UNITED STATES PATENT AND TRADEMARK OFFICE

APPLICATION NO.	FILING DATE	FIRST NAMED INVENTOR	ATTORNEY DOCKET NO.	CONFIRMATION NO.
10/662,200	09/11/2003	Gary C. Vanstone	EM-1991	9114
5179	7590	05/10/2005	EXAMINER	
PEACOCK MYERS AND ADAMS P C			NGUYEN, THONG Q	
P O BOX 26927			ART UNIT	
ALBUQUERQUE, NM 871256927			PAPER NUMBER

Office Action Summary

DETAILED ACTION

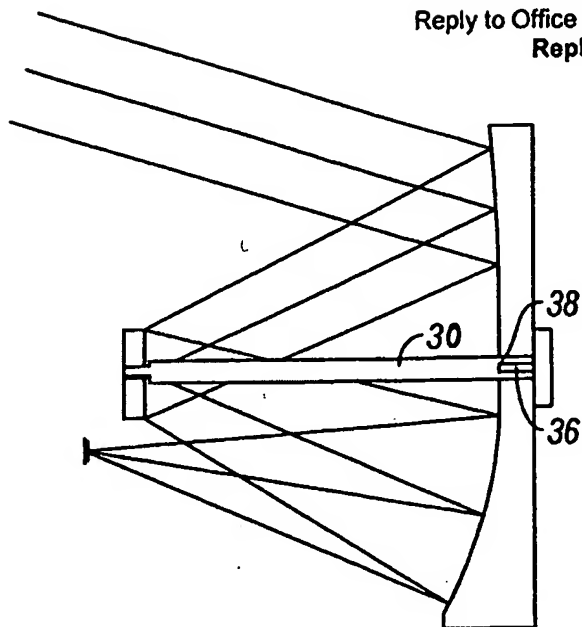
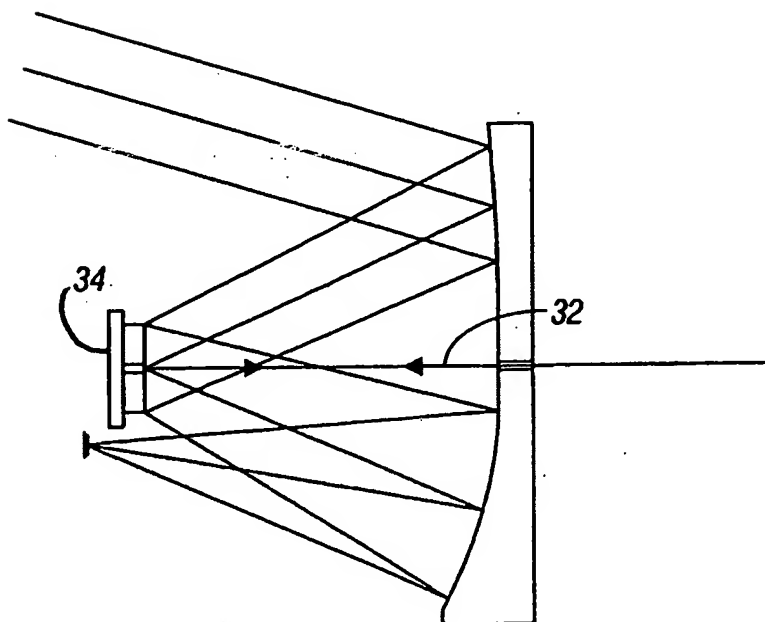
2. The drawings contained corrected figures 2-3 was received on 3/3/2005. These drawings are approved by the Examiner.
